GROUP CHA	MODEL Multiple Models
	NUMBER 074	DATE August 2016
TECHNICAL SERVICE BULLETIN		
SUBJECT: MDPS FLEXIBLE COUPLING REPLACEMENT

This bulletin is issued to provide information about the replacement of the flexible coupling in the MDPS motor of some vehicles which might experience a “knock” noise originating from the MDPS, when moving the steering wheel to right or left when the vehicle is stopped. This is caused by premature wear of the flexible coupling in the MDPS motor. If any “knock” noise from the MDPS occurs, replace the affected flexible coupling only with an improved one, following the Replacement Procedure below.

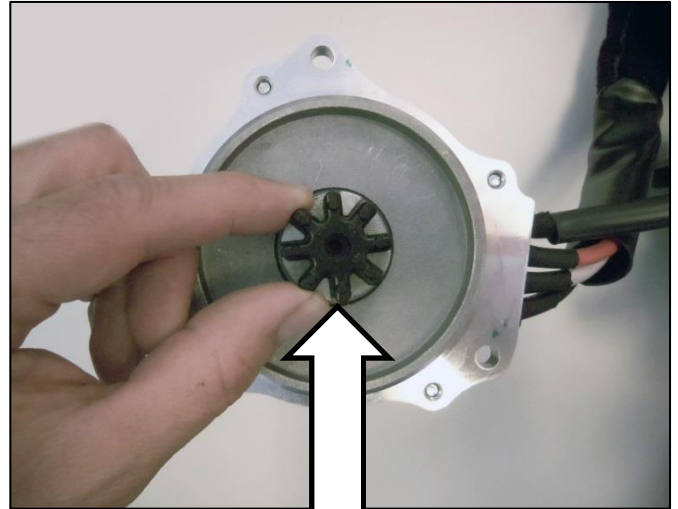
13. Replace the original flexible coupling with the new part. Refer to the graphic below to properly align the flexible coupling with the motor housing.

Before installing the new part, make sure it has “HNBR” embossed on the surface and is facing upward.

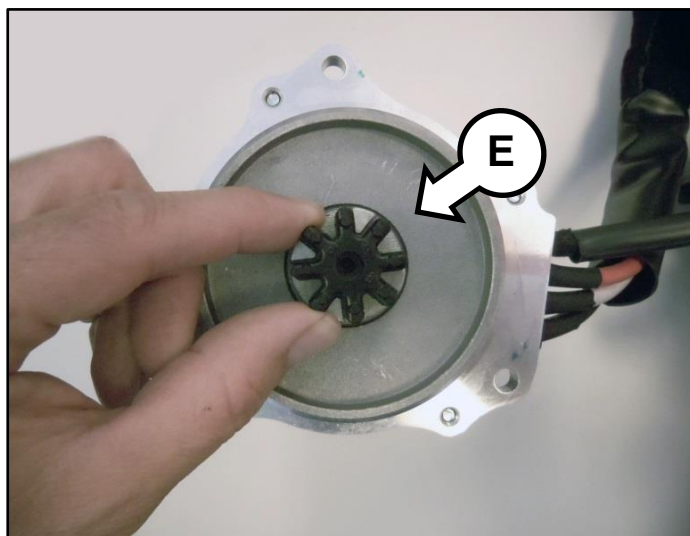
8. Install the new flexible coupling (E) onto the MDPS motor, as shown.

Before installing the new flexible coupling, make sure it has “HNBR” embossed on the surface and is facing upward.

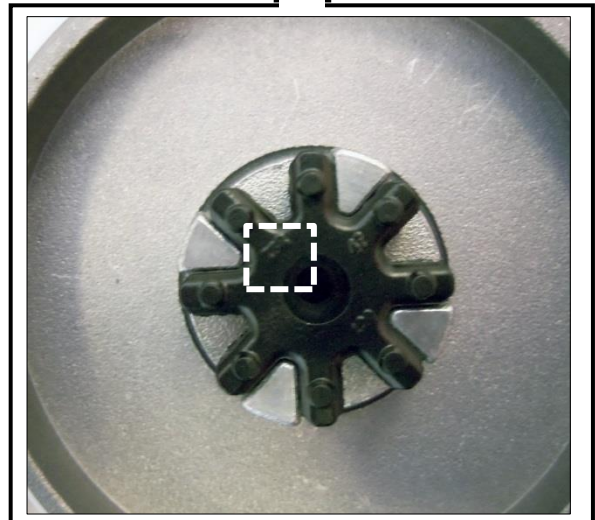
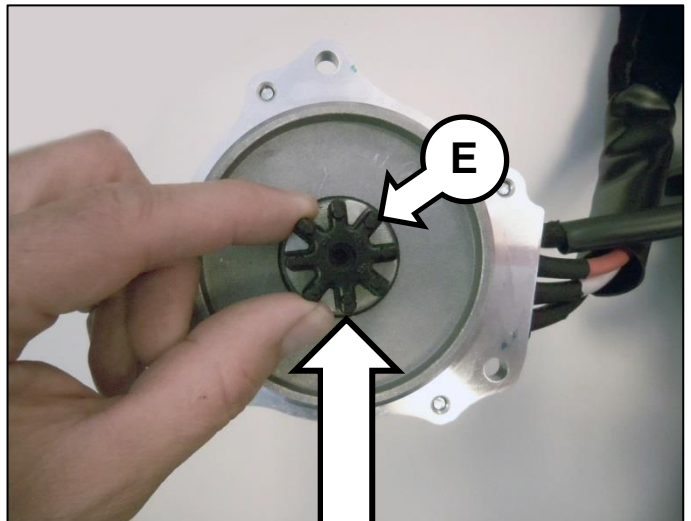
5. Install the new flexible coupling (E) onto the MDPS motor, as shown.

Before installing the new flexible coupling, make sure it has "HNBR" embossed on the surface.
